# Urgent Product Recall

**Re:** Proper Routing of Blood Tubing Set for MERIDIAN Instruments to Prevent Potential Kinking (Product Codes: 5M5576 and 5M5576R)

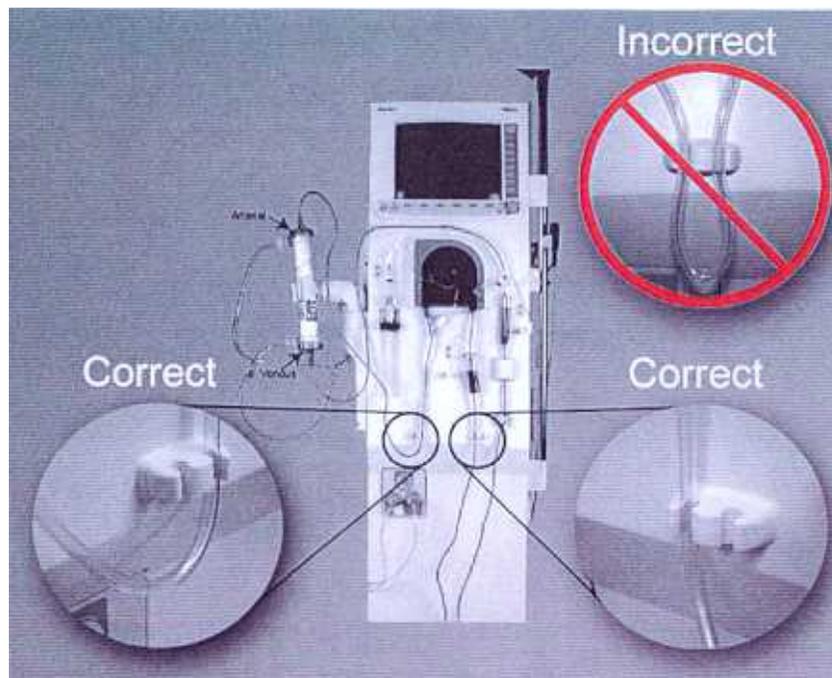
Baxter has received reports of hemolysis related to kinks in blood tubing sets used on the MERIDIAN instrument, which has contributed to a death and a serious injury. It has been determined that there is an increased risk for kinks to occur at the double-tubing clips mounted on the front of the MERIDIAN instrument. The risk increases when a single tubing line is routed through both retainers on either clip (please see 'Incorrect' view in picture below). Baxter Healthcare Corporation is providing you with the following information to ensure the safe and effective use of recommended blood tubing sets:

- Looping the arterial blood tubing set through both retainers of the double-tubing clip increases the risk of the blood tubing set kinking (see 'Incorrect' view in picture above), which could cause hemolysis. The clinical implication of returning hemolyzed blood to a patient is variable but ranges from no adverse effect, to symptoms including back pain, abdominal pain and shortness of breath, and ultimately, in the worst case, could lead to death.

- When setting up a recommended blood tubing set for the MERIDIAN Instrument, ensure that the arterial tubing between the blood pump and dialyzer and between the blood pump and the patient is routed through **only one of the two retainers in the double-tubing clip** (see 'Correct' views in picture below).

To correct this issue, Baxter is providing you and your staff with this letter and labels to be affixed to all your MERIDIAN instruments that provide proper instruction to route tubing through the tubing clips. In addition, Baxter will be providing an upgrade kit for both the pre- and post-blood pump double-tubing clips. Additional information regarding this kit will be communicated to you as it becomes available.

1. Affix one of the enclosed labels to each MERIDIAN instrument in your possession, as per the instructions accompanying this letter
2. Assure that all care providers are trained and follow the proper setup as outlined above and are using **only one of the two retainers in each of the double-tubing clips** during treatment.
3. Confirm that these two actions have been performed using the attached reply forms.

Proper Label Placement

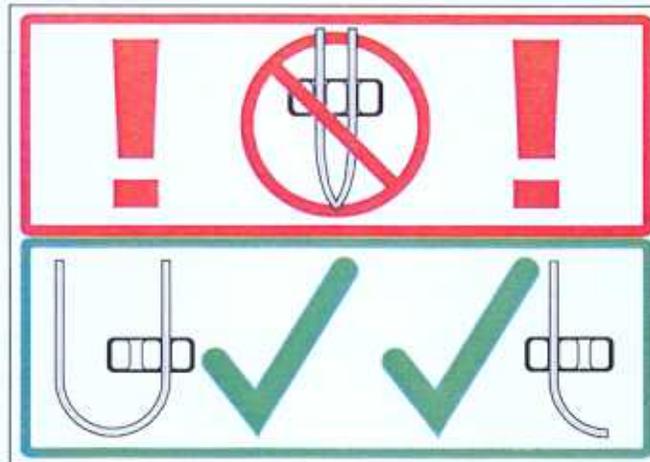
1. Remove any blood tubing sets from the Meridian Instrument.
2. Wipe the Front Panel area, where the label is to be attached with isopropyl alcohol.
3. Peel off adhesive backing from label.
4. Make sure to orient the label with the red text at the top and attach the label to Front Panel as shown.
5. Align the label with the vertical line molded onto the instrument housing and press the label flat from the side.

Align here

Align and flatten from the side
